6672A-08

S E R V I C E N O T E

6672A System DC Power Supply

Slow or No Down Programming capability

Pic_1

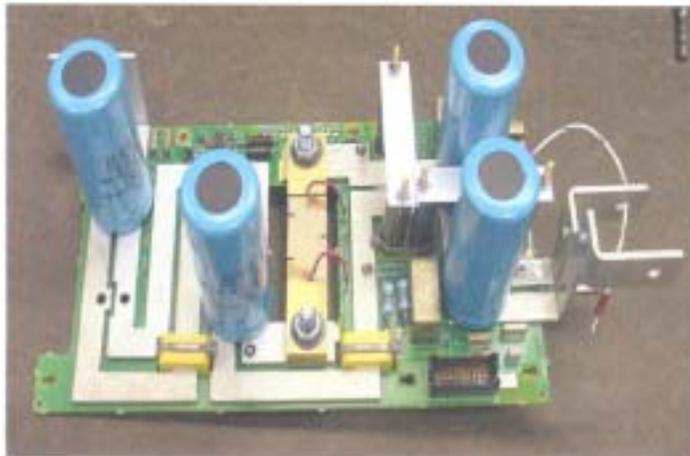
Change: Resistors Reference designator R911 and R912

From: Old part number 0699-1060 (0.05ohm +/-1%, 3W)

To: New part number 0699-1075 (0.1ohm +/-3%, 3W.) (See Pic_1)

Pic_4

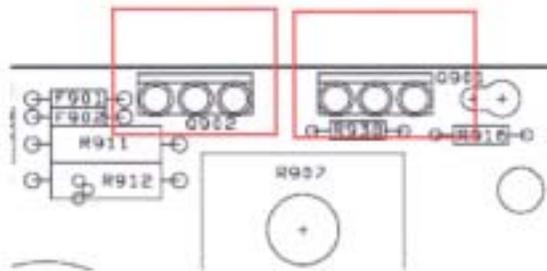
5. Remove Transistors Q901 & Q902, see Pic_4 for location.

Note: Some PCAs will have transistors installed in sockets. If so, remove sockets and replace with new sockets. Be careful not to get solder inside socket.

Note: Do not install Q901 and Q902 transistors until after PCA is put back into chassis.
